Work Order ID 52155

Item ID: D209-669-014

Item Name: Skidtube RH

DART SERVICE INSTRUCTION
TO AMEND INSTALLATION INSTRUCTIONS IIN-D209-669 REV. B

5.0 PARTS LIST

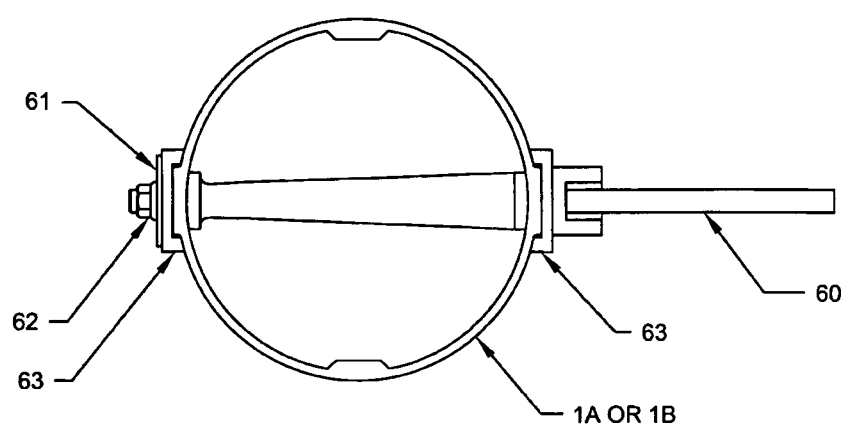
- a) REPLACE THE D2968-041 TOW RING WITH THE D3407-041 TOW RING ASSEMBLY.
- b) REPLACE THE D2736-1 AND D2736-3 GHW LUGS WITH THE D3405-041 AND D3405-043 LUG ASSEMBLIES.
- c) AMEND THE PARTS LIST IN SECTION 5.0 OF INSTALLATION INSTRUCTIONS IIN-D209-669 REV. B AS SHOWN ON PAGE 2 OF THIS DSI.

NOTE: ALL INSTALLATION FASTENERS FOR THE ABOVE CHANGES HAVE BEEN UPDATED. SEE THE AMENDED PARTS LIST ON PAGE 2 FOR DETAILS.

IS:

50	4	4	1	1			D3405-041	LUG ASSEMBLY
51	8	8	4	4			AN4C47A	BOLT
52	16	16	8	8			D2570	BUSHING
53	8	8	4	4			MS21043-4	NUT
54			1	1			D3405-043	LUG ASSEMBLY
60	1	1	1	1			D3407-041	TOW RING ASSEMBLY
61	1	1	1	1			D3456-1	WASHER
62	1	1	1	1			MS21043-4	NUT
63	2	2	2	2			D3417-5	WASHER

WAS:

50	4	4	1	1			D2736-1	GHW LUG
51	8	8	4	4			AN4-46A	BOLT
52	16	16	8	8			D2570	BUSHING
53	8	8	4	4			MS21042L4	NUT (OR MS21042-4)
54			1	1			D2736-3	GHW LUG
60	1	1	1	1			D2968-041	TOW RING
61	1	1	1	1			AN970-4	WASHER
62	1	1	1	1			MS21042L4	NUT (OR MS21042-4)

INSTALL TOW RING ASSEMBLY AS SHOWN BELOW (REFER TO SECTION F-F OF IIN-D209-669 REV. B.

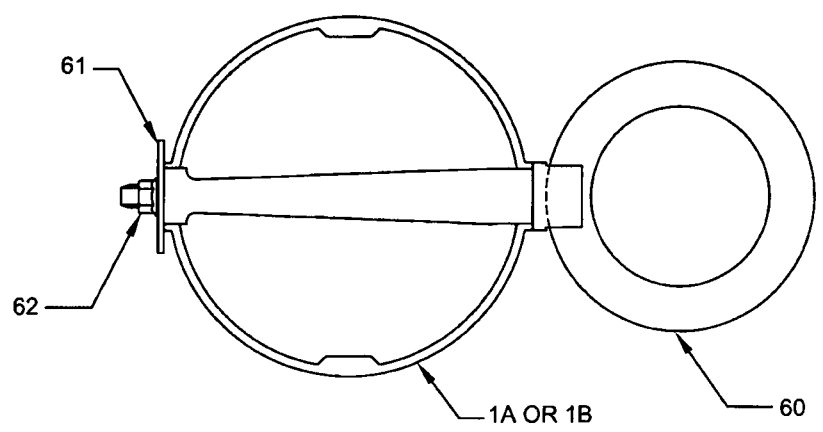
IS:

WAS:
